Interactive comment on “Geomorphometry of drainage basins: a global view from the Shuttle Radar Topography Mission” by P. L. Guth

Received and published: 9 May 2011

Fig. 1. Revised Figure 8

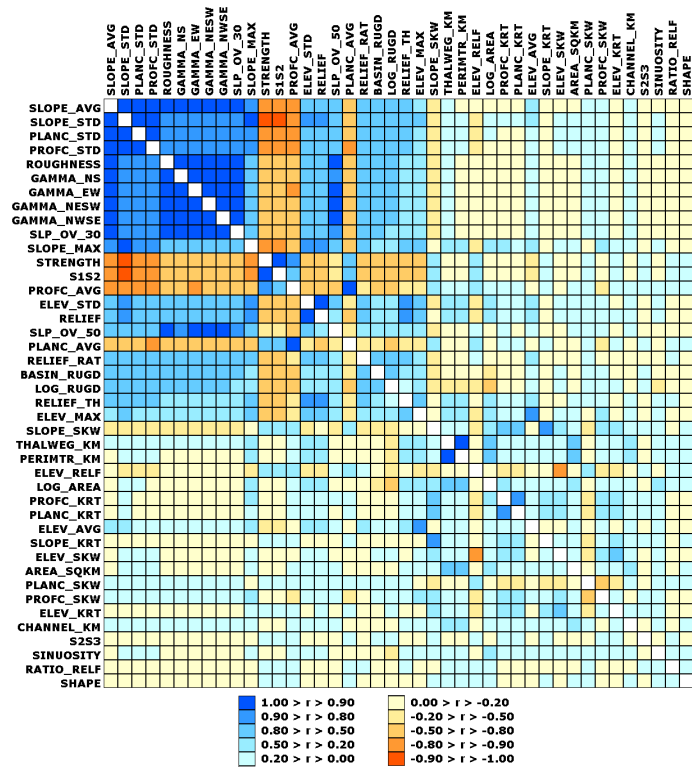
- Reviewer suggested to halve the Fig. 8 matrix, from a square to a triangle, to eliminate redundancy; I prefer to keep it, because it is easier to follow a single parameter by using a row of column, instead of having to do a pivot in the middle. Per the Evans review, the figure is also changed to place related variables closer together.
